ALERT SERVICE BULLETIN **BO105**

Change Order
No 4 for ASB BO105-90-103

No. ASB BO105-90-103

Subject: Starter-Generators - Inspection / Retrofit of a Ground Reference Connection

Starter-Generator
Figure 1

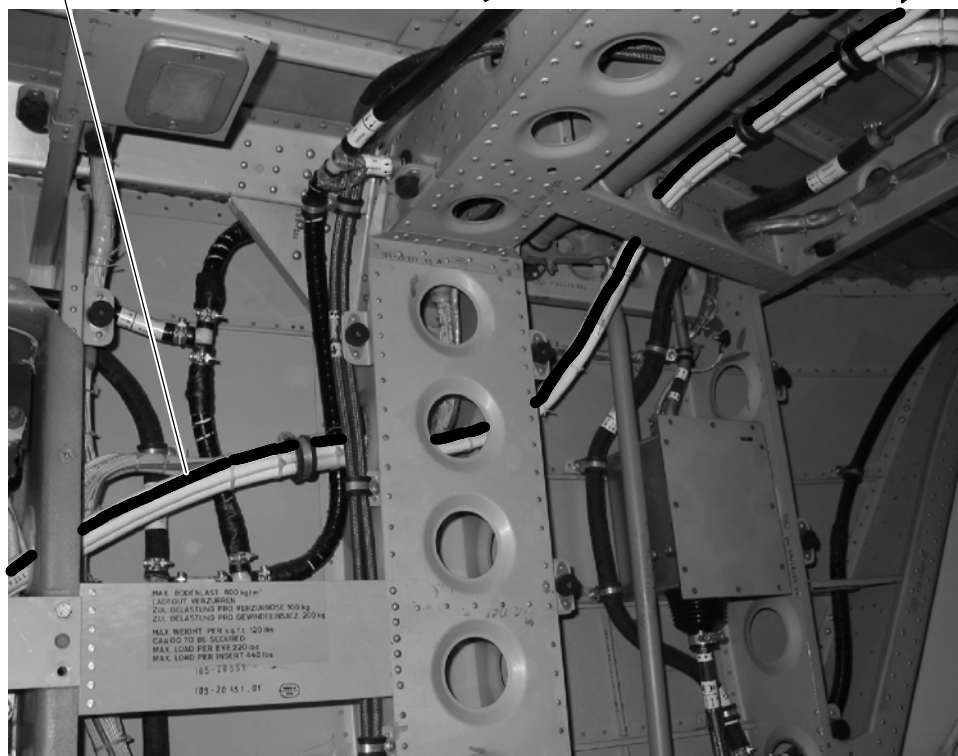
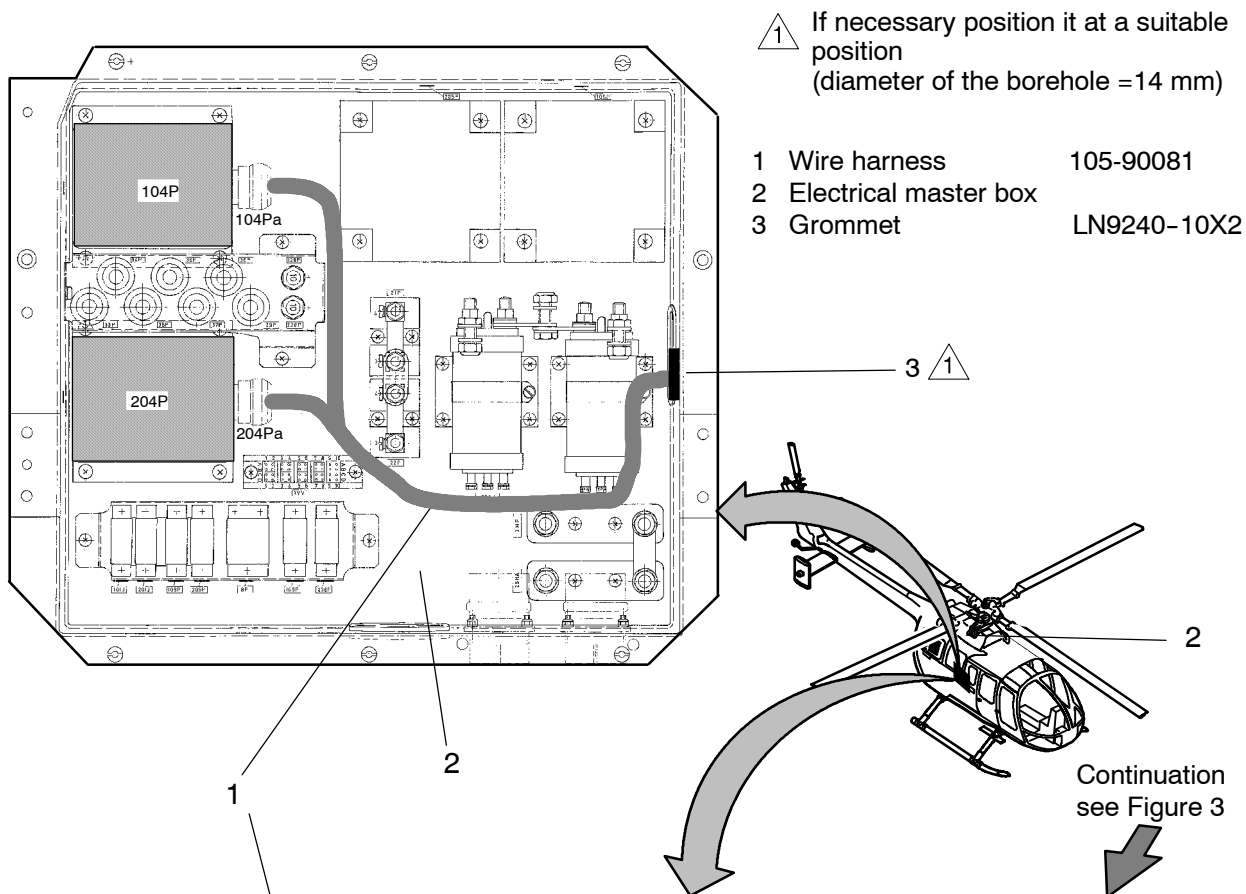
- 2.B.2.3. Loosen nut from terminal E of the starter-generator (see Figure 1) and store for reuse.
- 2.B.2.4. Disconnect wire P55F16N / P56F16N, (*P28F16 / P27F16*) (2, Figure 1) and, if necessary, the associated shield-grid lead from terminal E. Cut off wire P55F16N / P56F16N, (*P28F16 / P27F16*) and, if necessary, shield-grid lead immediately at the wire terminal. Slide heat-shrinkable sleeve onto wire ends and shrink on with a hot air blower.

- 2.B.2.5. Attach remaining wires to terminal E of the starter-generator using nut and torque-tighten to 25-26.5 Nm. While doing so, ensure that the wire terminals remain centrally aligned when they are tightened and that the wires are routed with a strain relief.

Typical Installation of Wire Harness (BO105, excluding Model D)
Figure 2

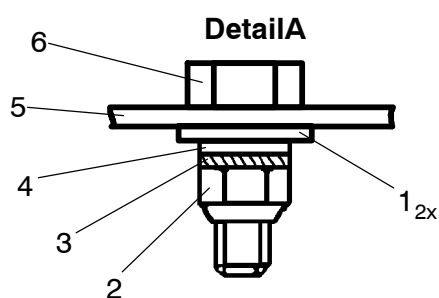
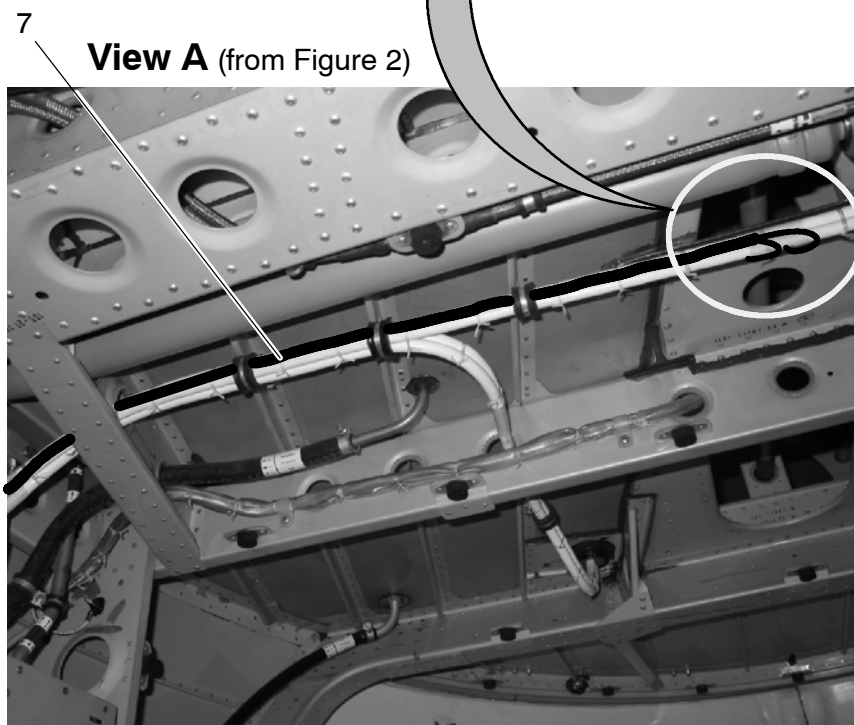
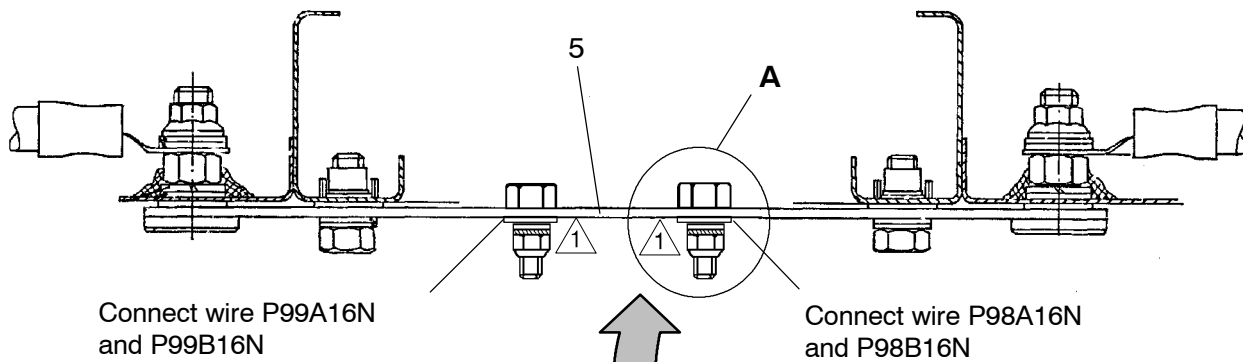
2.B.3.1. If necessary install grommet (3, Figure 2, 7) to a suitable position by drilling the installation hole in the electrical master box housing using a drill bit dia. 14 mm

2.B.3.2. Route wire harness i.a.w. Figure 2, 3, (3, 7) and fix. If installed, route wire harness within attachment clamps and chafing protection.

Typical Installation of Wire Harness with Grounding Bar installed as Standard Equipment
Figure 3

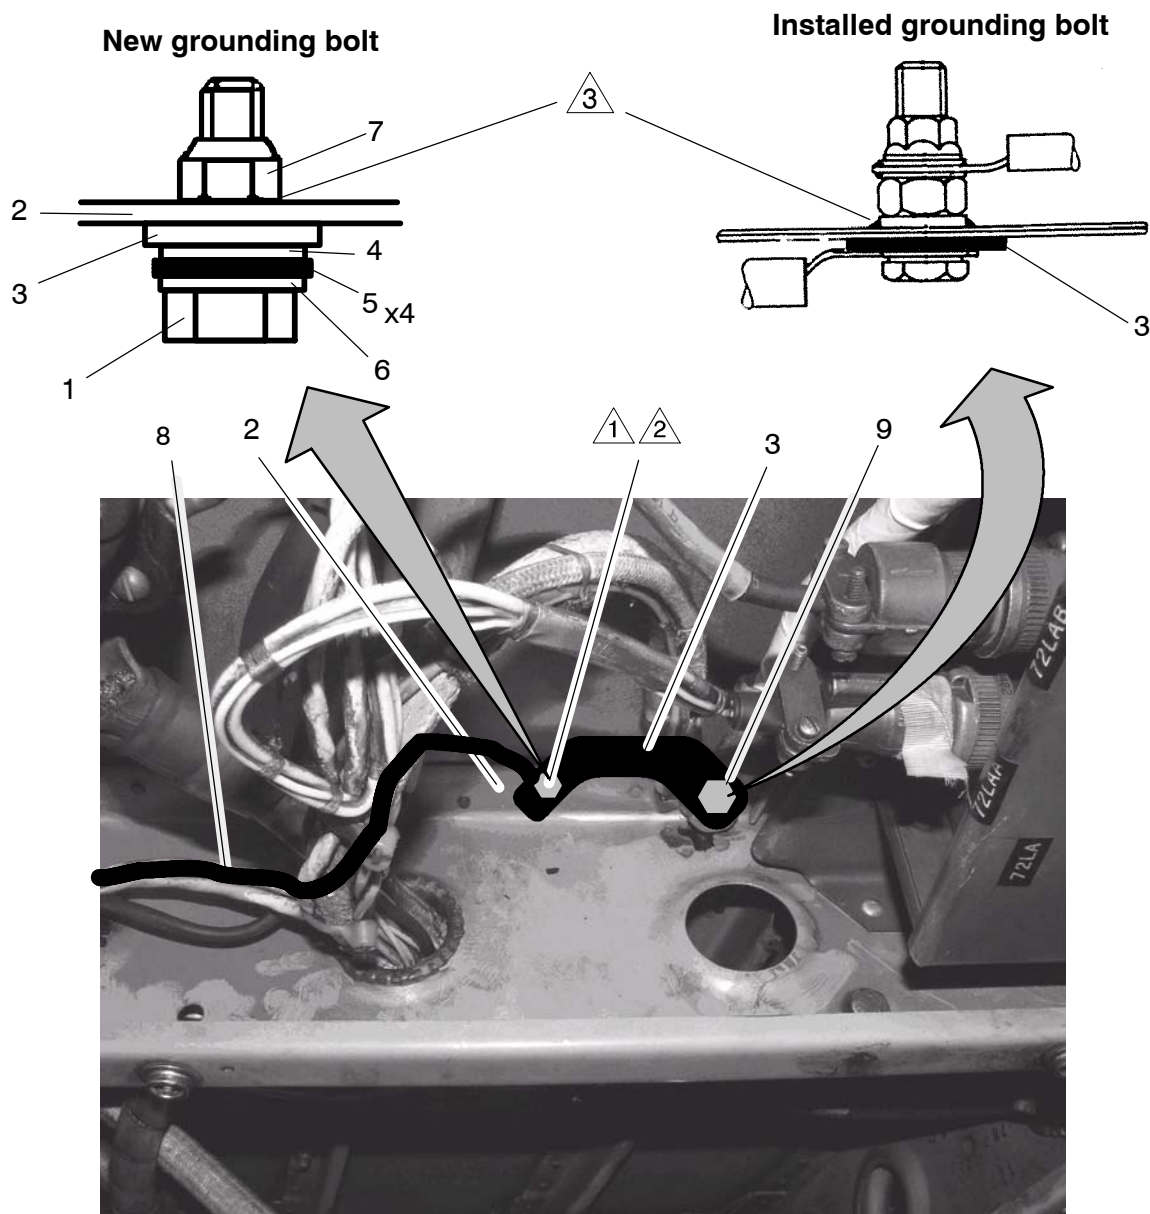
2.B.3.5. If grounding bar (5, Figure 3) is installed as standard item of equipment:
Screw wire terminals (1, Figure 3) of wires P98A(B)16N / P99A(B)16N onto grounding bar (5) i.a.w. Detail A, Figure 3.

△ 1 Faying surface free from insulating surface protection layer. Apply PU lacquer (CM 478, CM 479, CM 480) onto bare metal surfaces after assembly.

Wiring Diagram with Grounding Bars as Standard Item of Equipment
(BO105 excluding model D)
Figure 5

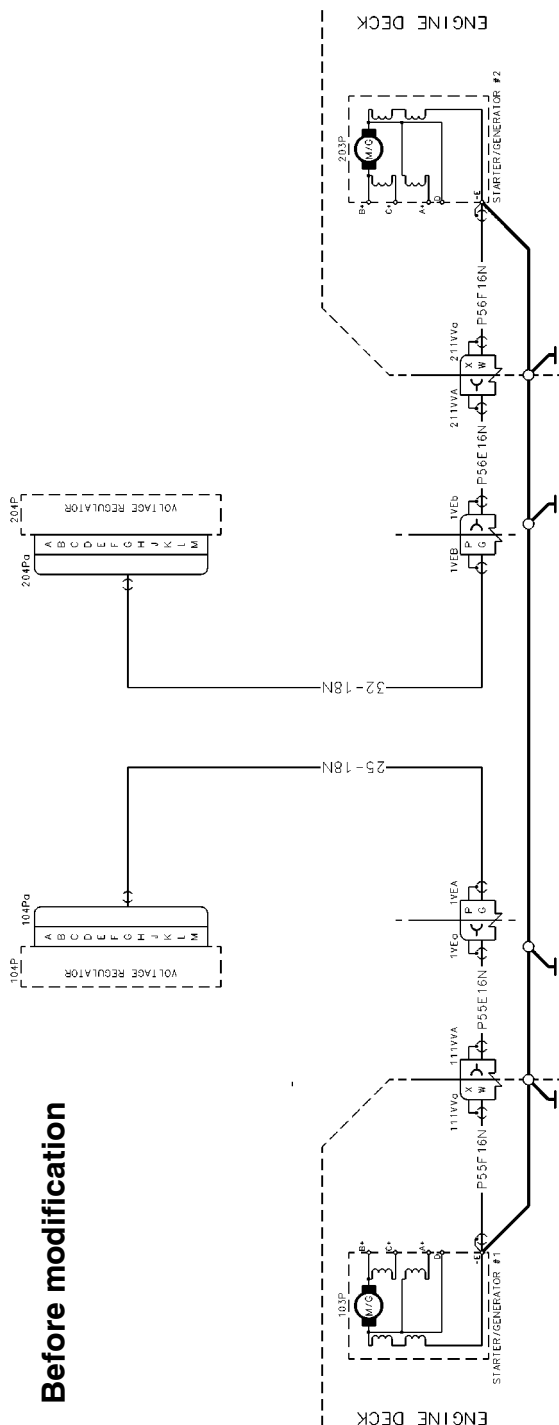
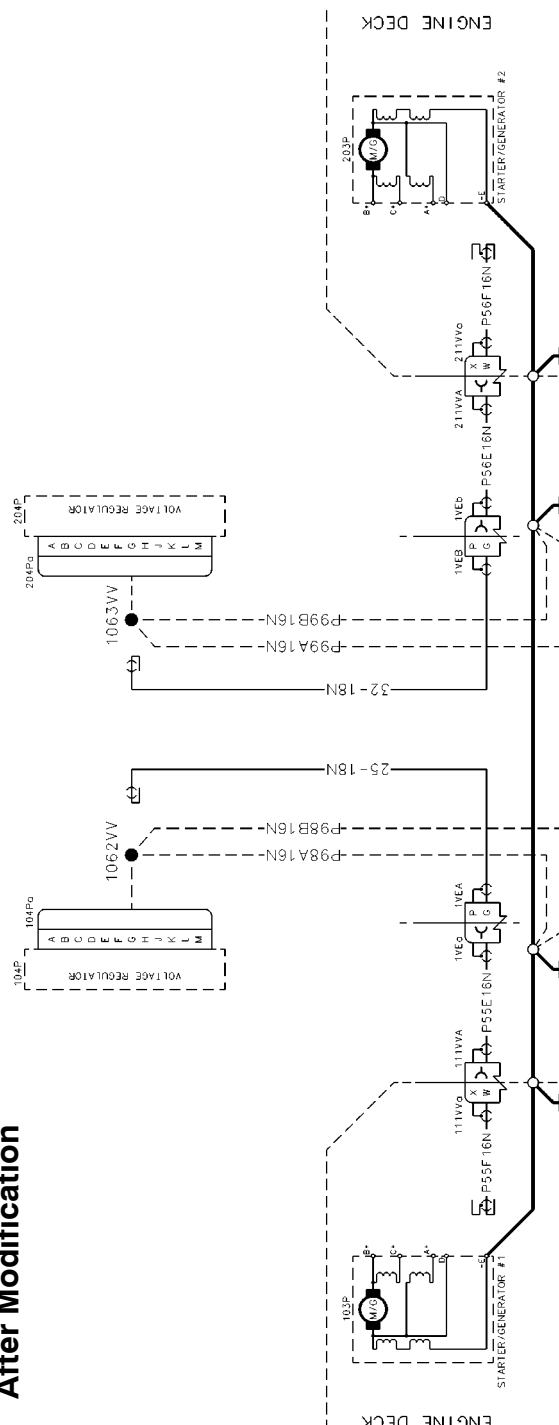
2.B.2.9. Disconnect wire 25-18N / 32-18N, (10-20 / 27-20) from contact location "G", "F" (see Wiring Diagram, Figure 5, 6), (8, 9). Cut off wire immediately after the contact. Slide heat-shrinkable sleeve onto wire end and shrink on with a hot air blower.

2.B.3.3. Insert wire of wire connector SP1062VV / SP1063VV in plug 104Pa / 204Pa, (108Pa / 208Pa), contact location "G", "F" (see Wiring Diagram, Figure 5, 6, (8, 9)).

Typical Installation of Wire Harness (BO105 model D)
Figure 7

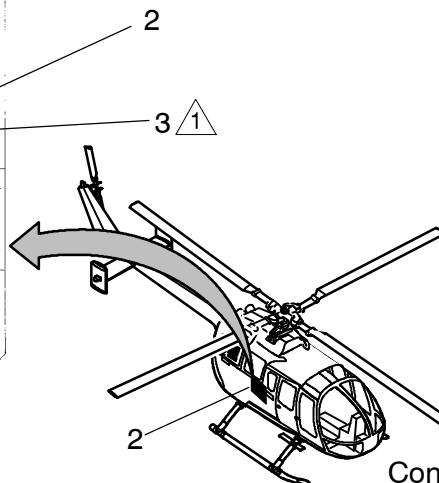
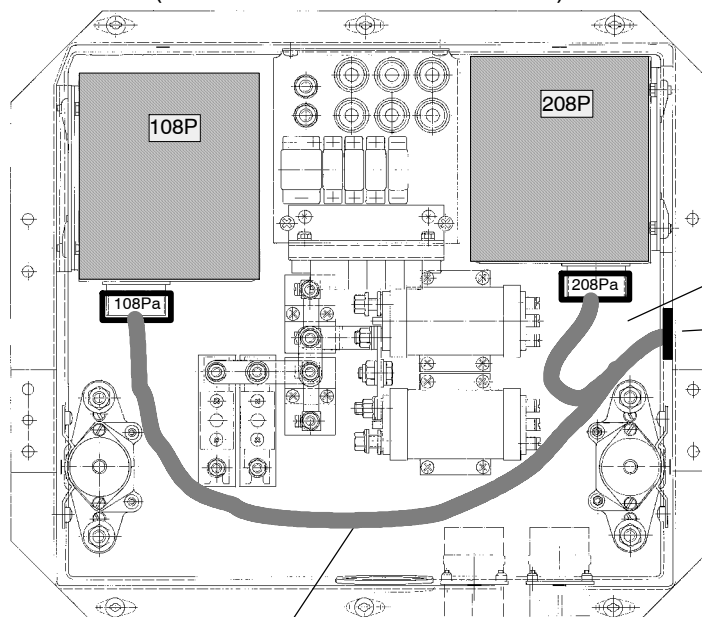
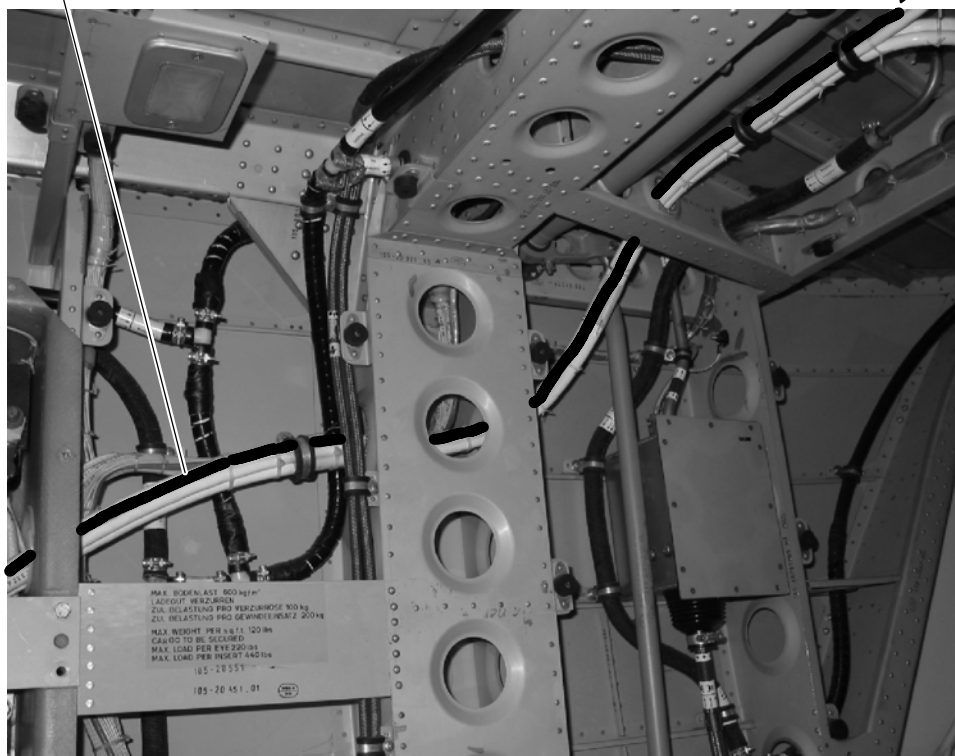
- 2.B.2.7. Install engine cowling i.a.w. MM MBB-BO105, chapter 22.
- 2.B.2.8. Loosen end ring from plug 104Pa / 204Pa, (*108Pa / 208Pa*) and disconnect plug from generator voltage regulator 104P / 204P, (*108P / 208P*) (Figure 2), (*Figure 7*) in the electrical master box.
